Stressed receiver sensitivity setup and calibration (comment 304)

Piers Dawe and Jakob Toft
NVIDIA

Comment 304

Figure 121–8—Stressed receiver conformance test block diagram

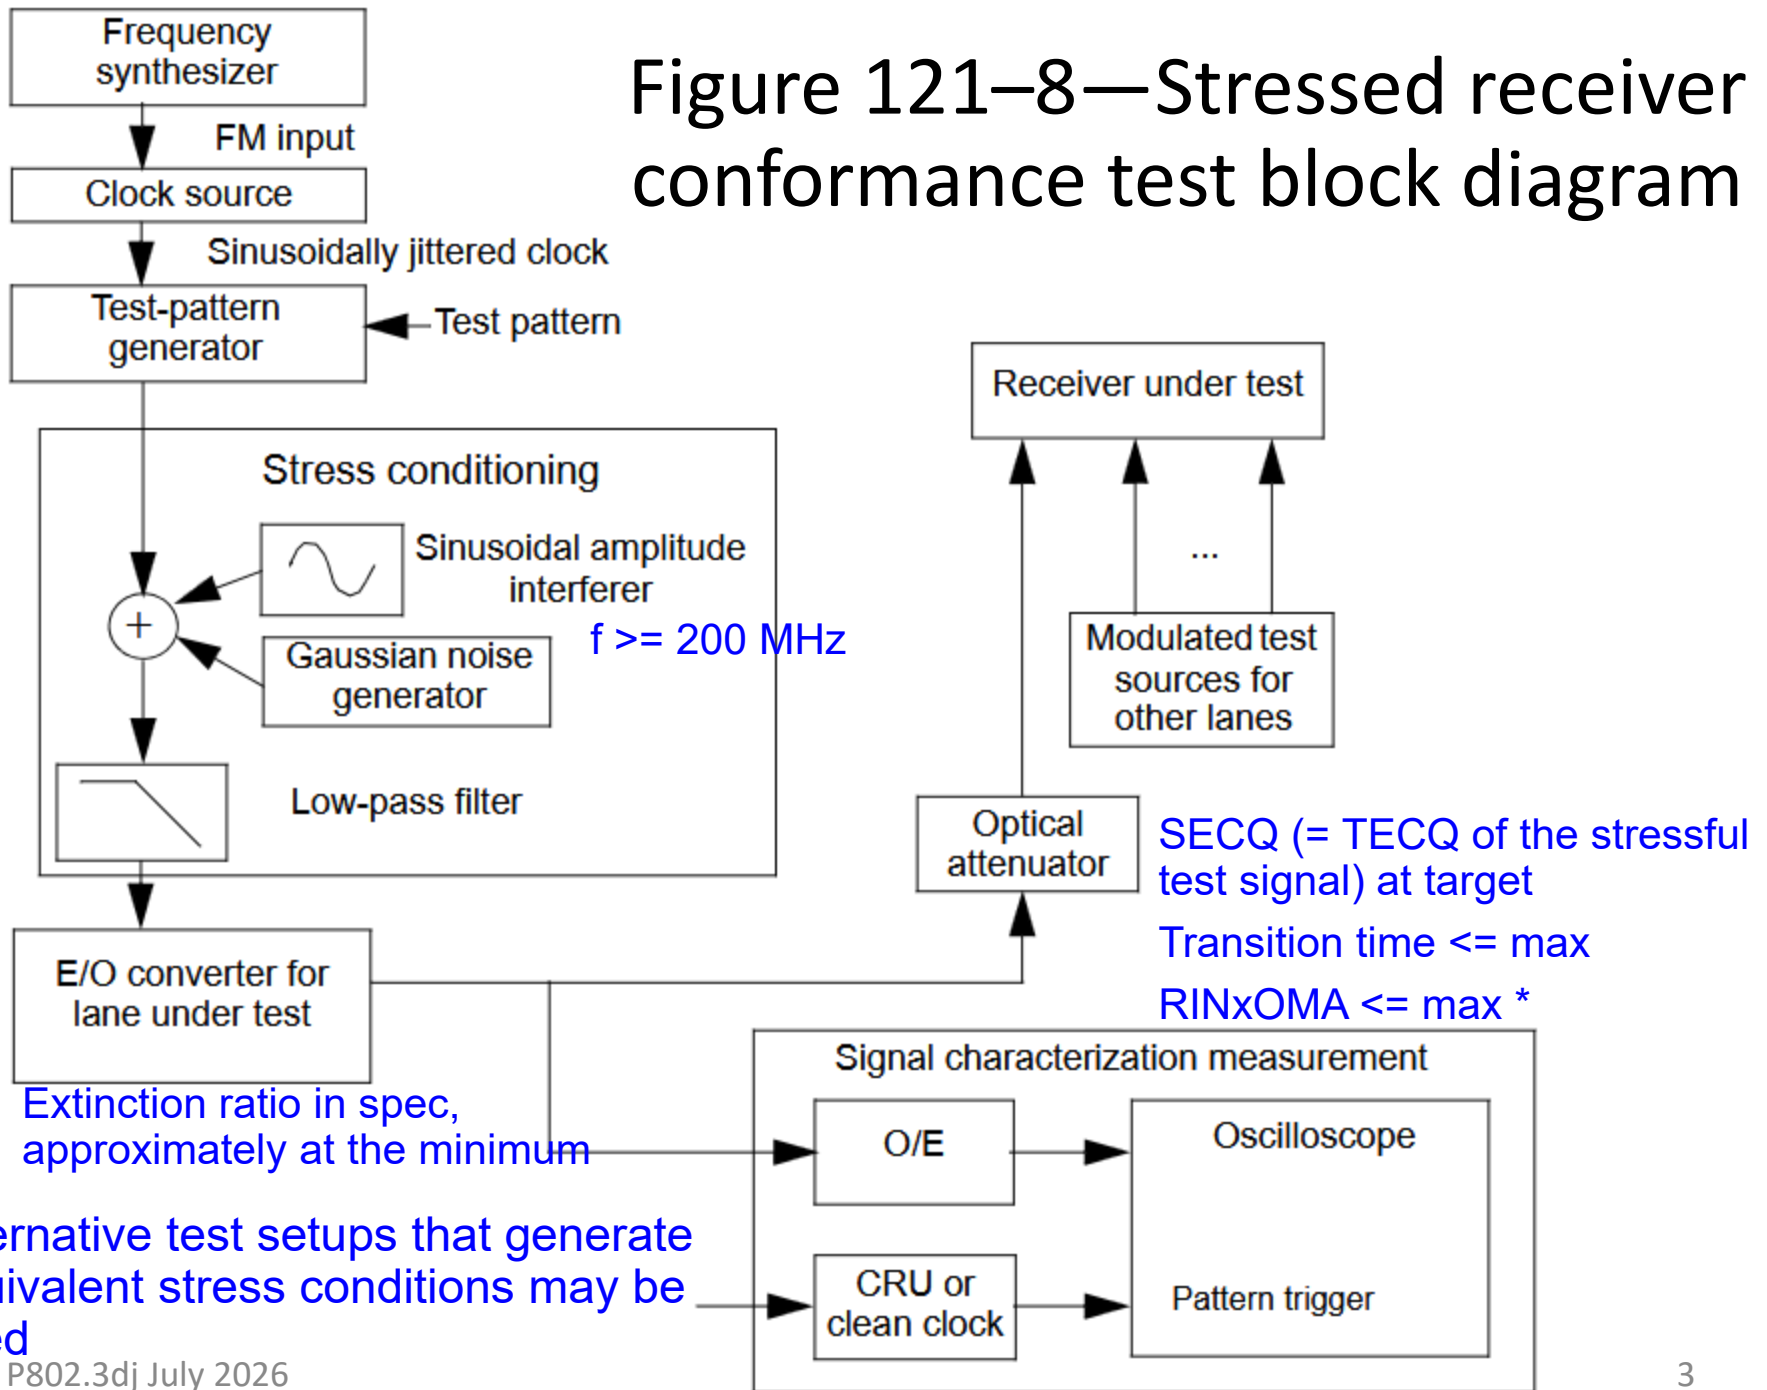
- The sinusoidal amplitude interferer may be set at any frequency between [200] MHz and 2 GHz, although care should be taken to avoid harmonic relationships between the sinusoidal interferer, the sinusoidal jitter, the signaling rate, and the pattern repetition rate. The Gaussian noise generator, the amplitude of the sinusoidal interferer, and the low-pass filter are adjusted so that the specified SECQ is met.
- For improved visibility for calibration, all elements in the signal path ... should have wide and smooth frequency response, and linear phase response, throughout the spectrum of interest. Baseline wander and overshoot and undershoot should be negligible.

The implementer chooses the mix of filtering, Gaussian noise and SI amplitude. Also the SI frequency

Some choices can give very unrealistic signals

Often the penalty from SI is very large

SECQ variability

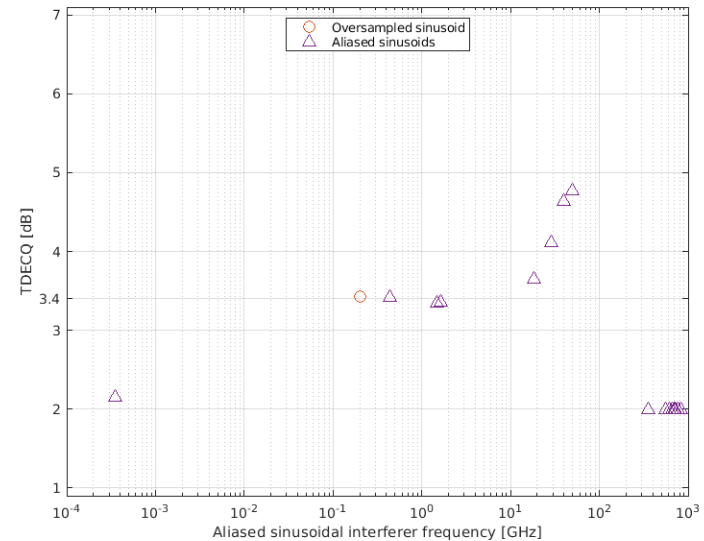
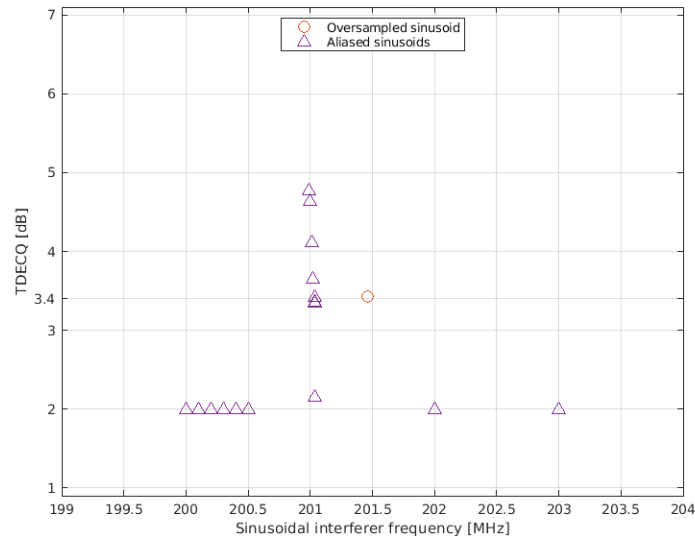
- Simulations with the same SI amplitude at different frequencies give very different (apparent) SECQ
- In calibration, the SI amplitude would be adjusted to make the apparent SECQ to the target, giving very different real stress

- With a PRBS interferer, there are many frequencies. They are aliased too, but to many frequencies which are noise-enhanced differently, leading to better consistency
- To avoid the 2-moded histogram problem, a PAM4 PRBS may be preferable to a PAM2 PRBS
- The amount of bounded interferer (SI or PRBS) should be limited, and more use made of the Gaussian noise generator
- The GN should represent some of the distortion in a bad signal, and be definitely more than the RIN limit
- We should say that with bounded interferer off and other impairments on, the SECQ should be within 0.5 dB of the target SECQ with all impairments on
 - This leaves the implementer with enough freedom to set the mix
